Invalid Application

Application reference number: PAN-029812

Site reference: Rhydlanfair, Afon Iwrch

○ **Location plan**

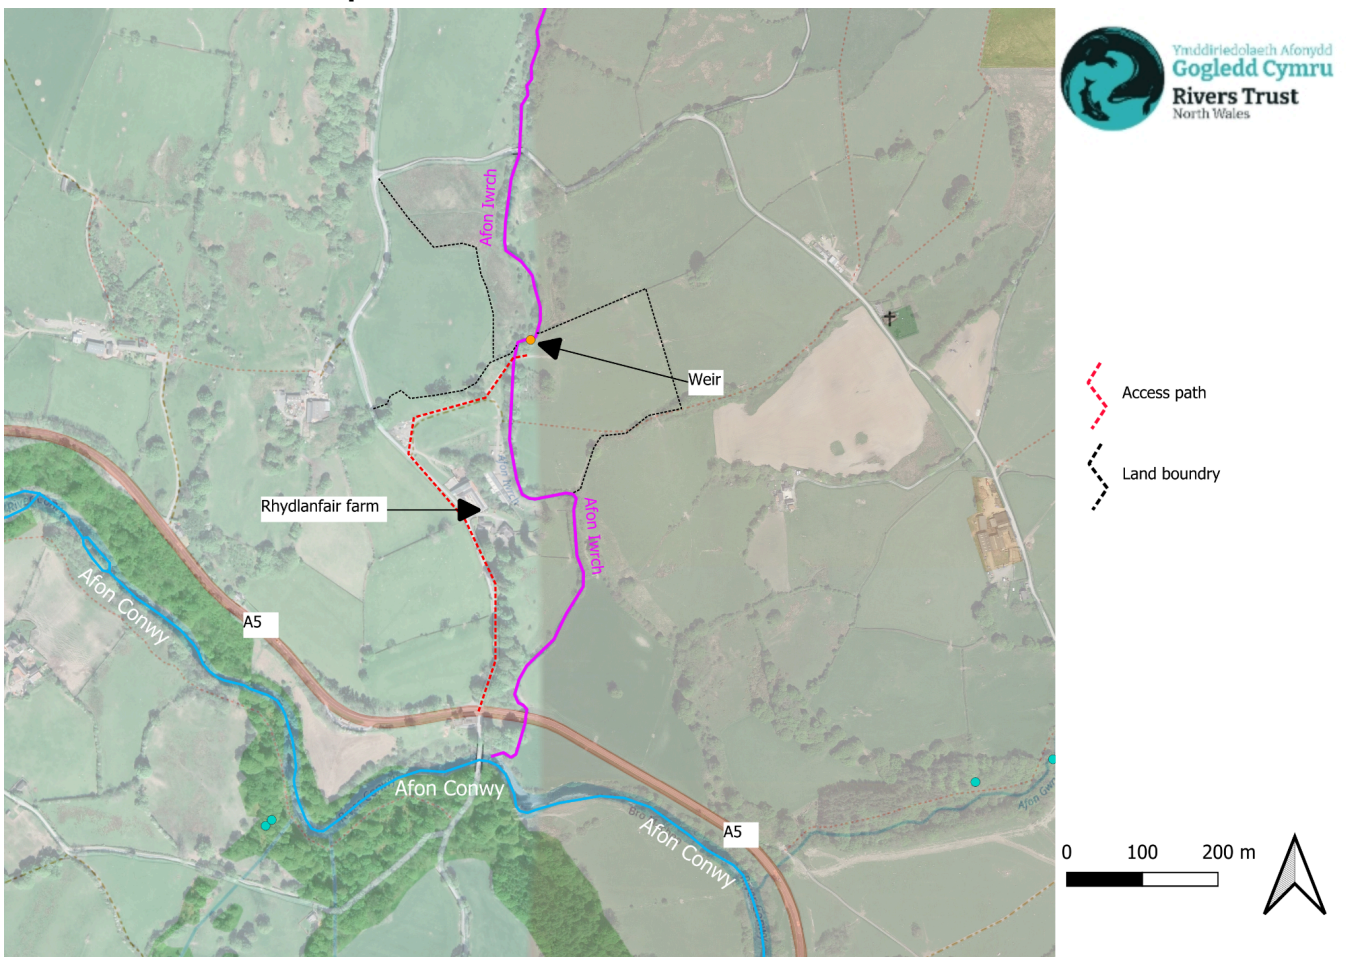
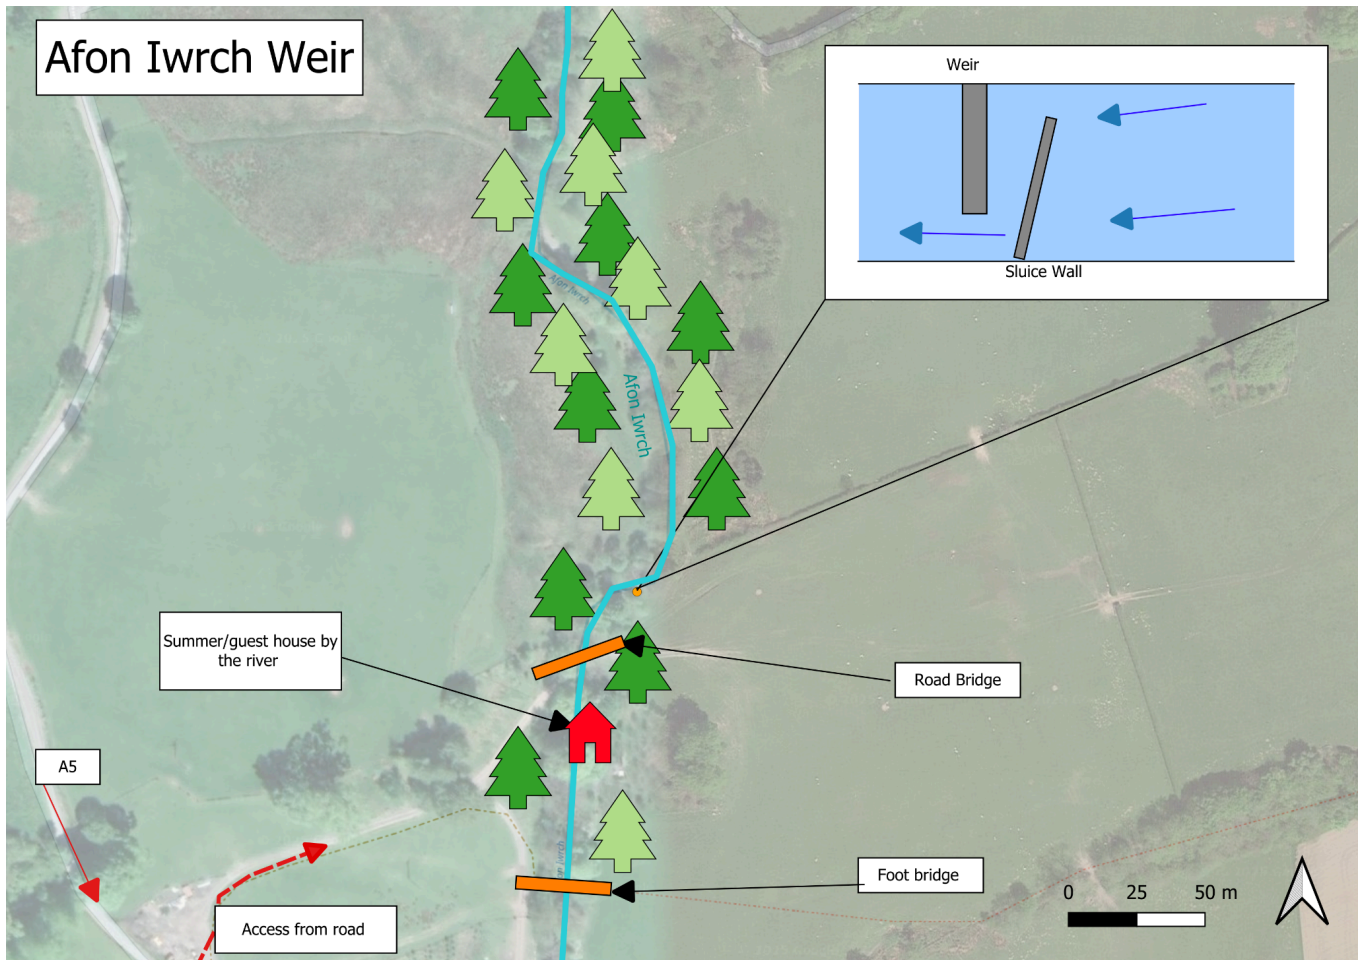
□ Please provide a location plan, plan, profile and cross-section design drawings in line with the above minimum requirements.

□ **NWRT Response:**
